UNITED STATES PATENT AND TRADEMARK OFFICE

APPLICATION NO.	FILING DATE	FIRST NAMED INVENTOR	ATTORNEY DOCKET NO.	CONFIRMATION NO.
10/721,128	11/25/2003	Bruce D. Dike	08814-00006	6196
21918	7590	02/17/2005	EXAMINER	
DOWNS RACHLIN MARTIN PLLC			JUBA JR, JOHN	
199 MAIN STREET			ART UNIT	
P O BOX 190			PAPER NUMBER	
BURLINGTON, VT 05402-0190			2872

Office Action Summary	Application No. 10/721,128	Applicant(s) DIKE, BRUCE D.	
	Examiner John Juba, Jr.	Art Unit 2872

DETAILED ACTION

FIG. 2.

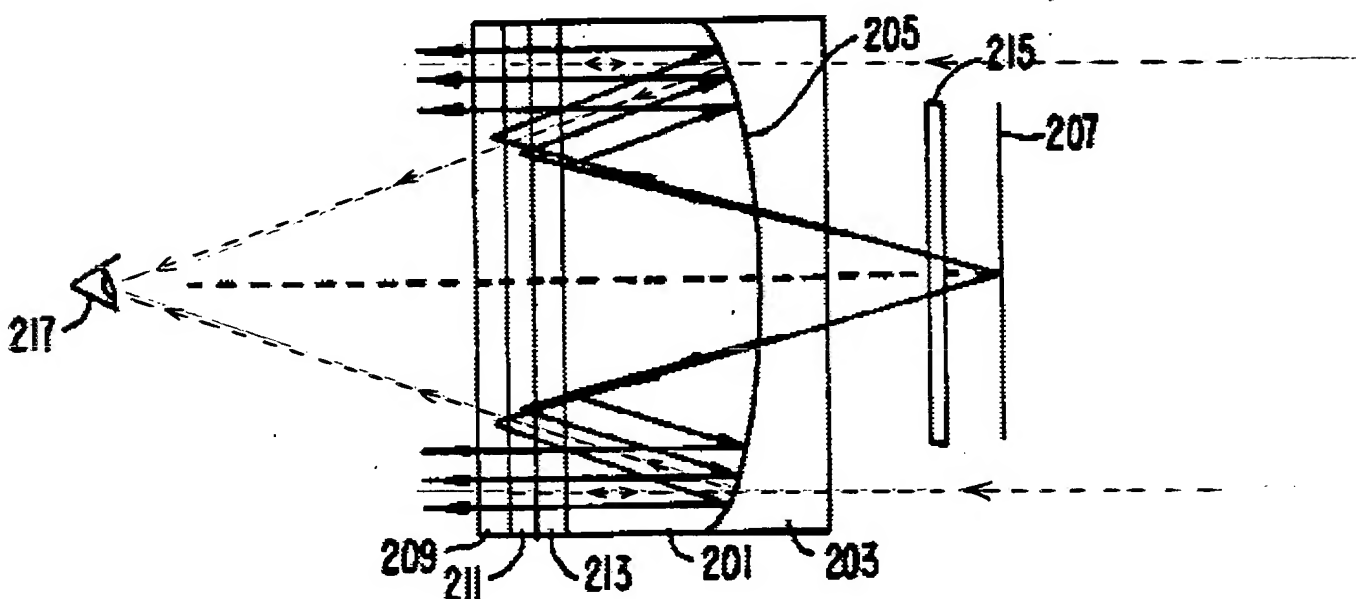
Claims 1, 6, 8, 12, and 13 are rejected under 35 U.S.C. 102(b) as being anticipated by Hoppe (U.S. Patent number 5,715,023), or in the alternative, under 35 U.S.C. 103(a) as being unpatentable over Hoppe (5,715,023), in view of PHILIPS ELECTRONICS (EP 0 606 940 A2). Referring to Figure 2 and the associated text, Hoppe discloses an optical system that will form a real image from a collimated light source, comprising:

at least one converging element (205) that will converge a portion of the light source so as to form a real image *when* the optical system is in use to form such an image; and

a broadband reflector-polarizer (209)(211)(213) located in an optical path between said at least one converging element and the real image and opposite the source *when* the optical system is in use to form a real image.

The recitation that the optical system is "for forming a real image from source light" is not seen as distinguishing the recited structure over the structure of the prior art, since the prior art is *inherently* capable of forming a real image of a collimated light beam arriving from the right (in the figure). For clarification, the examiner has marked-up a copy of Hoppe's Figure 2 below (the dotted lines are the examiner's).

Unlike the collimating embodiment, when the system is used to form a real image, the rays of different wavelengths will trace the same paths. The examiner believes that since Hoppe discloses the stack of cholesteric layers as providing multicolor or “wider bandwidth” operation (Col. 6, lines 3 – 5), one of ordinary skill would regard the collection of cholesteric layers as a “broadband” reflective polarizer, within the specificity recited. Thus, Hoppe is believed to anticipate the recited structure. However, if Hoppe does not anticipate a “broadband reflector-polarizer”, then in the same field of endeavor, PHILIPS ELECTRONICS teach that prior art broadband “polarizers” obtained by serially stacking a plurality of cholesteric layers having different band-pass characteristics suffer from several drawbacks including disclinations, loss of planar molecular order, and angular dependence stemming from requisite large thicknesses. In order to overcome these limitations, PHILIPS ELECTRONICS teach that a single cholesteric layer can be provided with a variable pitch so as to provide a broadband polarizing characteristic.

With regard to claims 6, 8, and 12, the converging element of Hoppe is a beam splitter (205) located between the source and the real image *when* the optical system is used to form a real image, as set forth above.
